May 5, 1983

Docket Nos. 50-338
and 50-339

SUBJECT: RADIOLOGICAL EFFLUENT TECHNICAL SPECIFICATIONS (RETS) FOR THE
NORTH ANNA POWER STATION, UNITS NO. 1 AND NO. 2 (NA-1&2)

Figure 1. Liquid Radwaste Treatment Systems, Effluent Paths, and Controls for North Anna Power Station Units 1 and 2

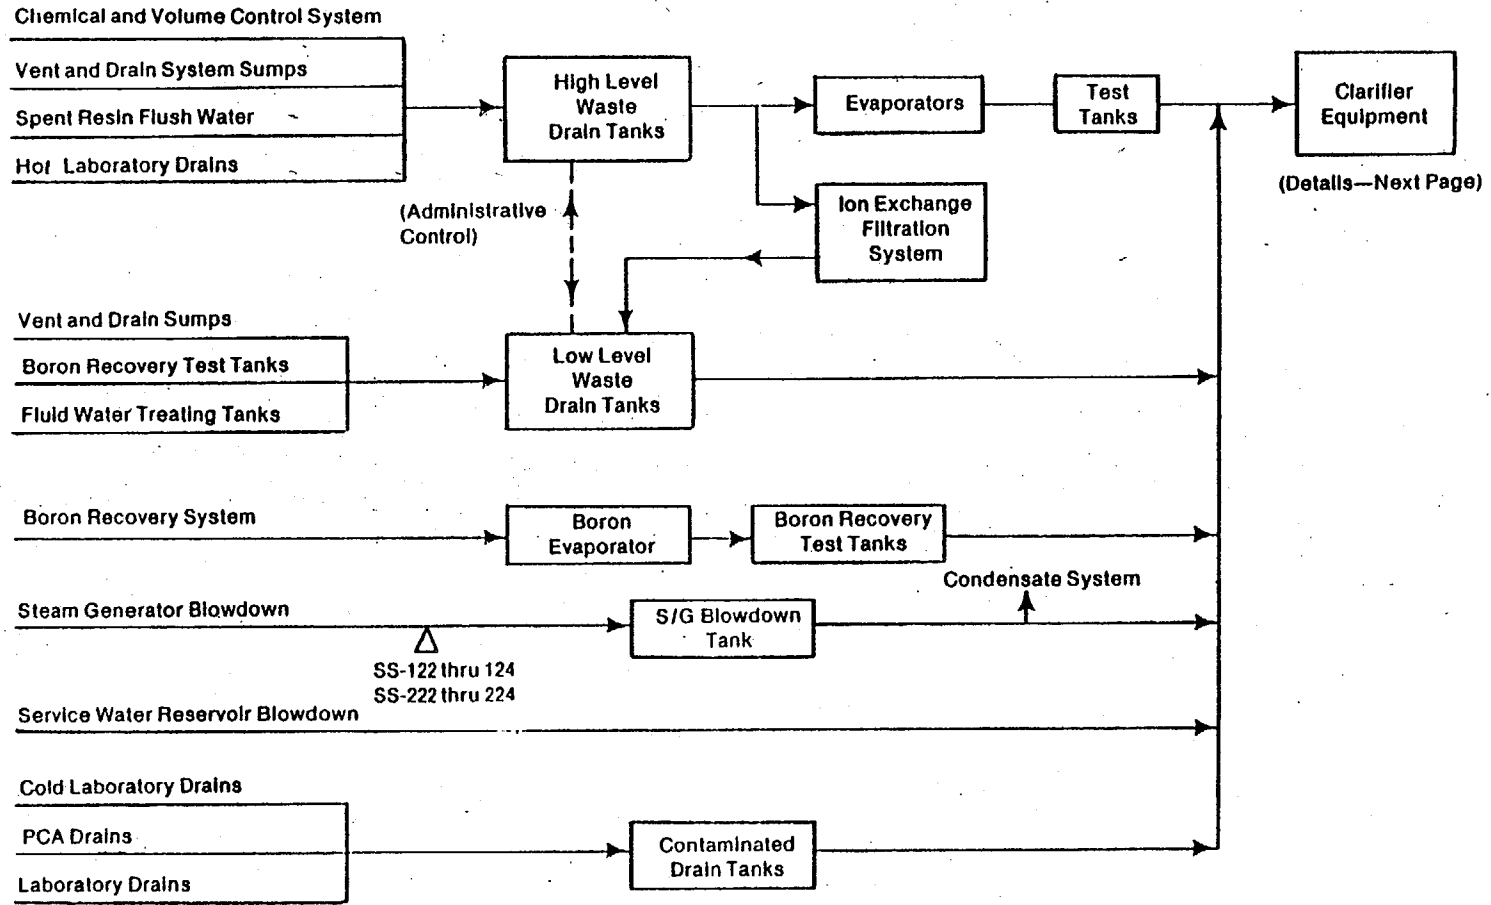
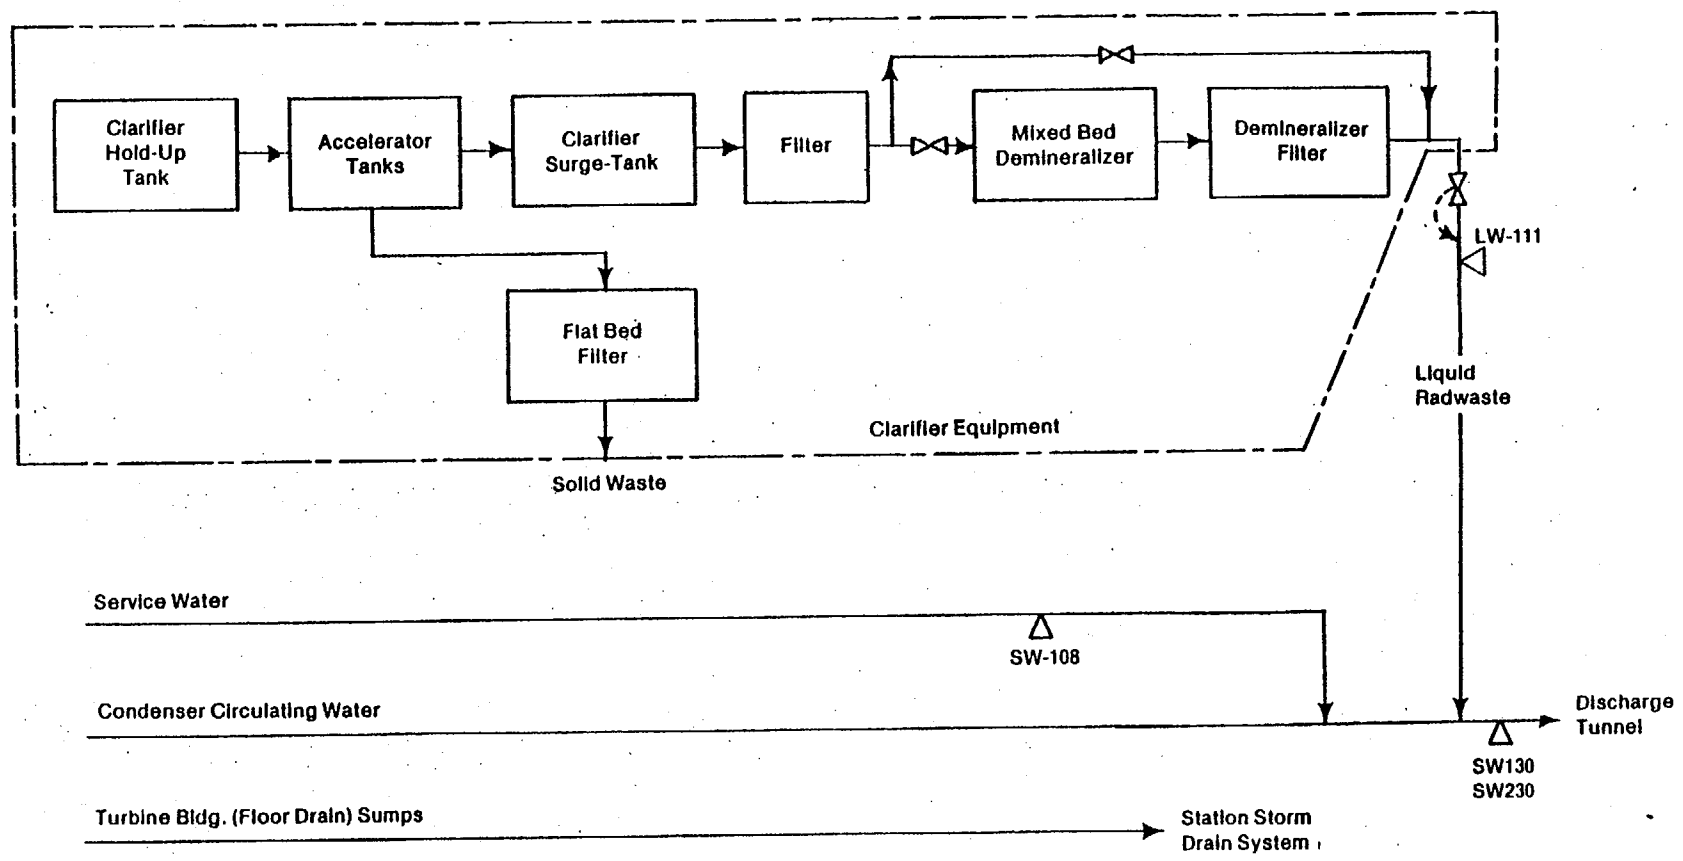
The liquid waste treatment system for the North Anna plant is common to both Units 1 and 2 (Figure 1). The liquid waste is primarily collected in high- and low-level waste drain tanks. This includes chemical and volume control, vent and drain sumps, spent resin flush, and hot laboratory drains for high-level waste; and vent and drain sumps, boron recovery test tanks, and fluid water treatment for low-level waste. All liquid waste is dumped into clarifier equipment which separates, through flat bed filters, the solid waste. The liquid radwaste effluent is then passed through demineralizers and then to the discharge tunnel. The liquid radwaste effluent line is monitored by LW-111, which provides alarm and automatic termination capability. The service water effluent line is monitored by SW-108. These two effluents lines, together with the condenser circulating water, lead to the circulating water discharge tunnel where monitors (SW-130, SW-230) are installed to monitor the liquid effluents before discharging into Lake Anna. The turbine building (floor drain) sump effluents are released directly to the station storm drain system; however, the Licensee does not provide on-line monitoring for this effluent line.

Figure 2. Gaseous Radwaste Treatment Systems, Effluents Paths, and Controls for North Anna Power Station Units 1 and 2

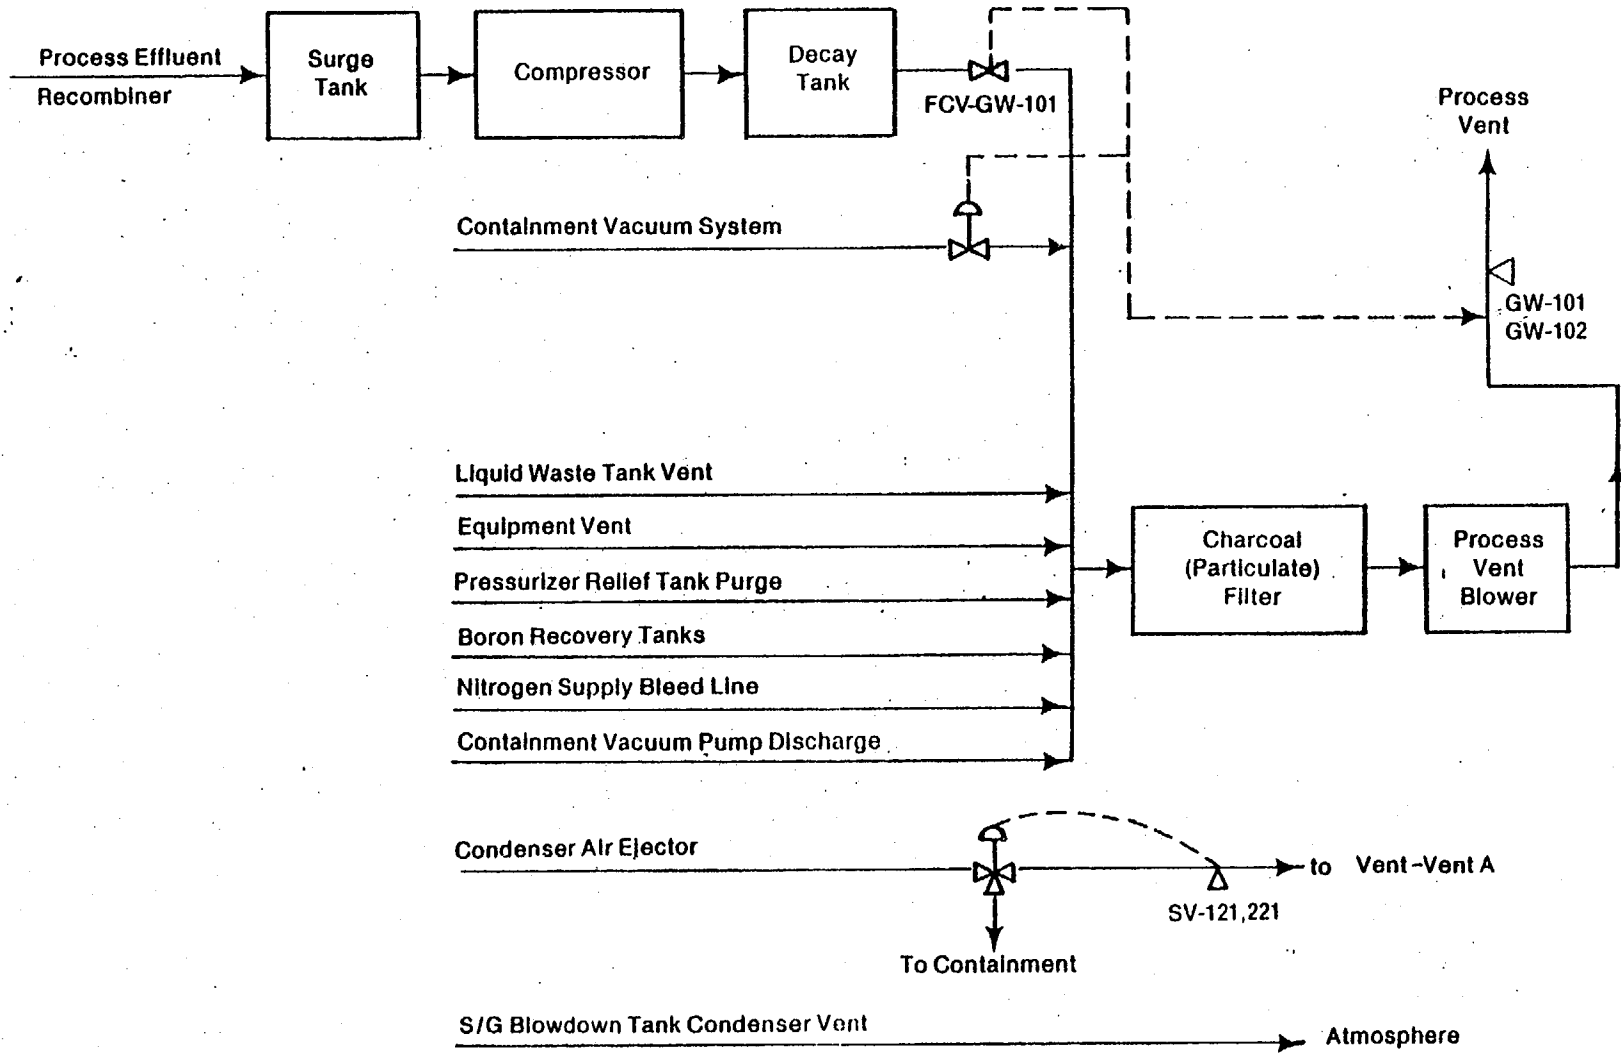
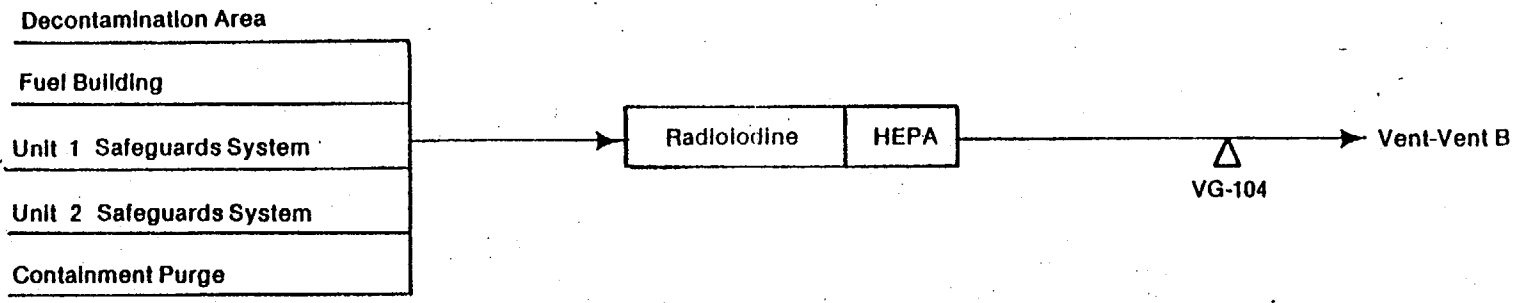
- An error was found in the gaseous flow diagram, in which the main condenser air ejector effluent should be substream to the vent-vent A rather than to the vent stack A, as indicated in your ODCM.
- You have not included the process vent monitor (GW-101) in the gaseous setpoint calculation, although the monitor has been identified in the flow diagram provided in your ODCM.
